**From:** Daniel Hatab <daniel.hatab@ramapocom.com>  
**Sent:** Friday, April 2, 2021 10:34 AM  
**To:** CSC-DL Siting Council <Siting.Council@ct.gov>  
**Subject:** EM-CING-153-201105 (AT&T Site CTL01835)

**RE:** EM-CING-153-201105  
**Subject:** Special Inspection Letter – Final Certification  
**ATC Site:** Watertown CT – 283424  
**AT&T site:** CTL01835 – FA:10128117  
**Site Address:** 655 Bassett Road  
Watertown, Ct. 06795-1139  
**AT&T Scope of work:** 3C,4C,4TX4RX Retrofit, 5G NR – Antenna Amendment Drawings  
**SMW Engineering Project:** 20-10237.1

**REDLINED CDs**  
**Ramapo Communication Corp**  
**3/23/2021**  
**Matthew Schlosser**  
*Matthew Schlosser*

3 PROPOSED SQUID MOUNTING  
 SCALE: NOT TO SCALE

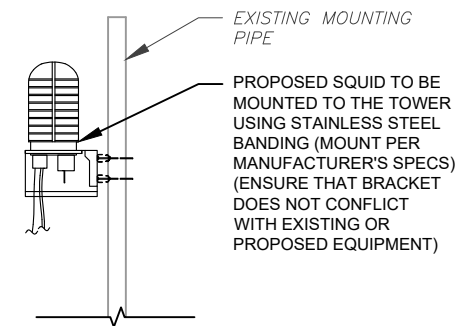
FINAL FIBER DISTRIBUTION/SQUID		
MODEL NUMBER	STATUS	CD
(2) DC2-48-60-8-18F-02	RMN	REDLINED CDs Ramapo Communication Corp 3/23/2021 Matthew Schlosser
DC2-48-60-8-18F-02	ADD
